**Comments and Proposed Alternative by Dan Johnson**  
**Albany Resident, Beach User, Bay Trail Commuter Cyclist**  
4/16/17

**Albany Beach Restoration and Public Access Project at Eastshore State Park – Phases 2 and 3**  
**BCDC Permit Number 2014.005.01**  
**Exhibit package dated 4/17/17**

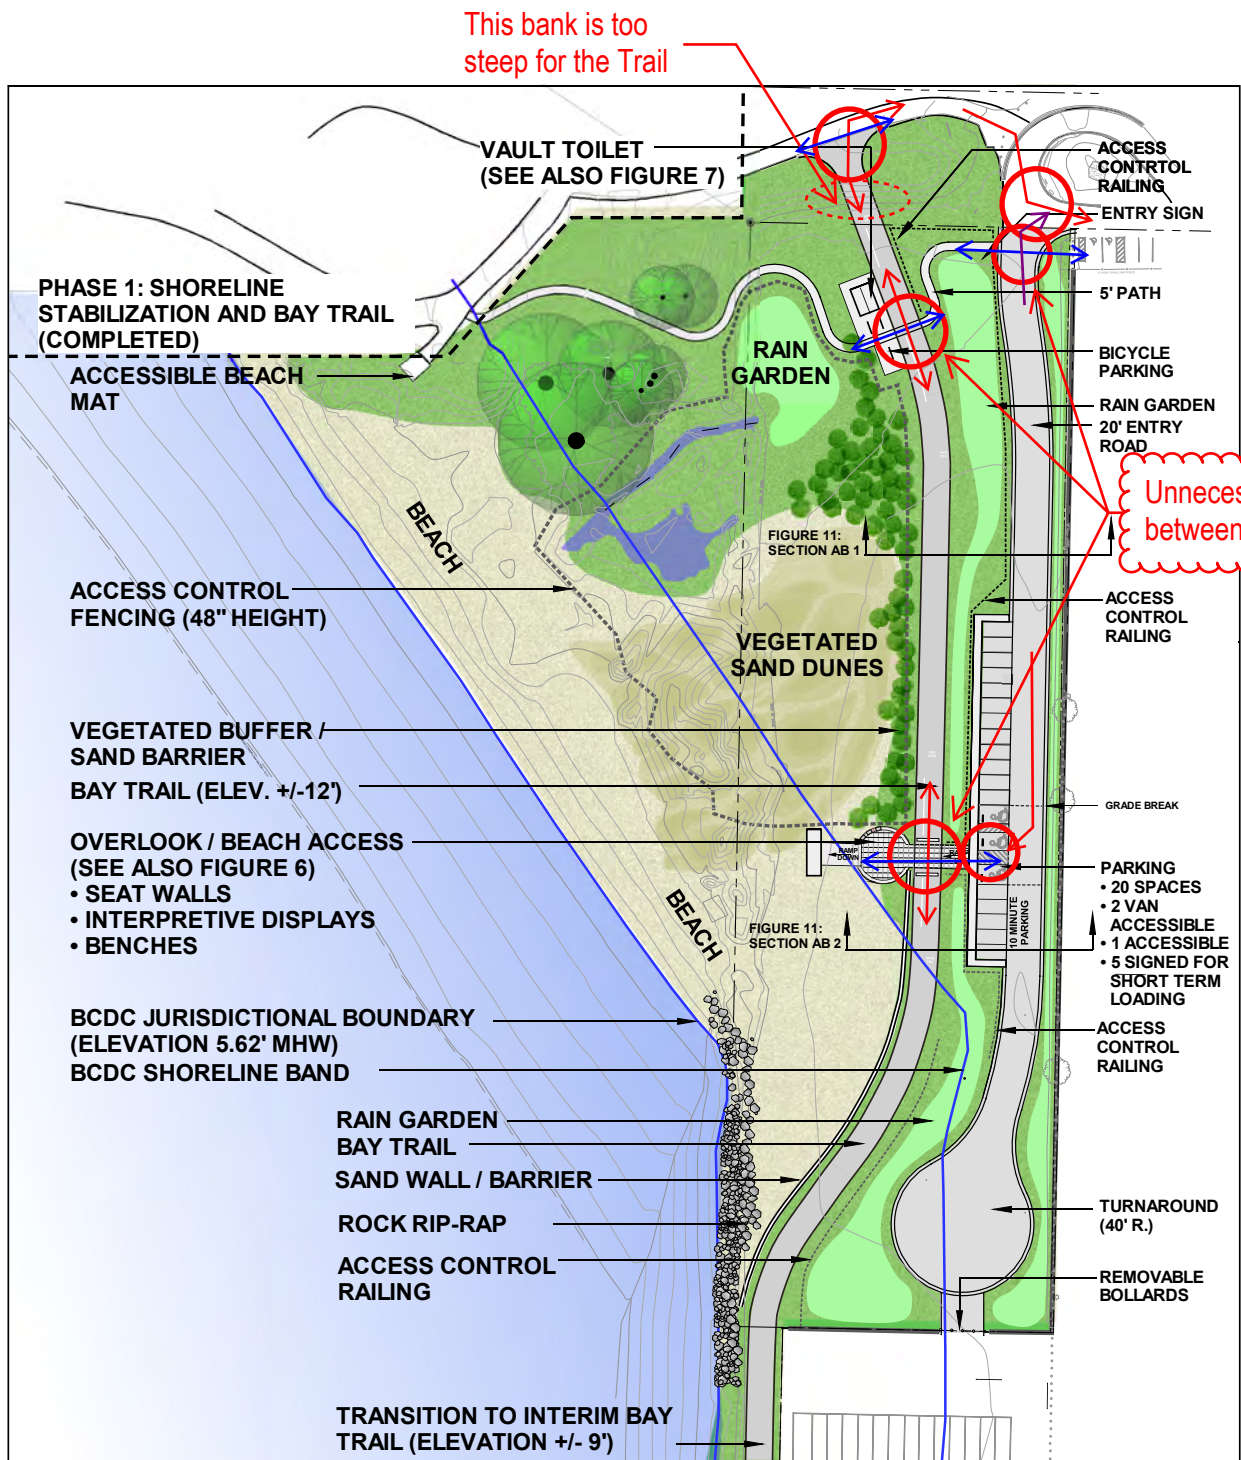
**8. Flood level.** I bike through this property on my commute to work. There is already 8" of standing water at the north end of the property after a big rain, making it impassable. Slide 19 notes that "a storm surge could add 2 to 2.5 feet to that indicated." The slide shows that the proposed Trail is level with the 2017 100-yr flood elevation. Does it make sense to design a throwaway facility that could be destroyed by next year's 100-yr flood?

Why not elevate the Trail as a 3'-high causeway on the back (east) side of the property, to keep it dry for decades to come? The sea level in 30 years is estimated to be 16" higher, as noted on the slide. A Trail on the east would also remove the risk of kids crossing the Trail from the vehicle parking to access the beach. You get better views from a higher Trail. Concentrate the parking on the north end, consolidate this with existing development, and elevate the parking area on 18"-24" of fill to keep it dry. Much less flood damage to the facilities for decades to come.
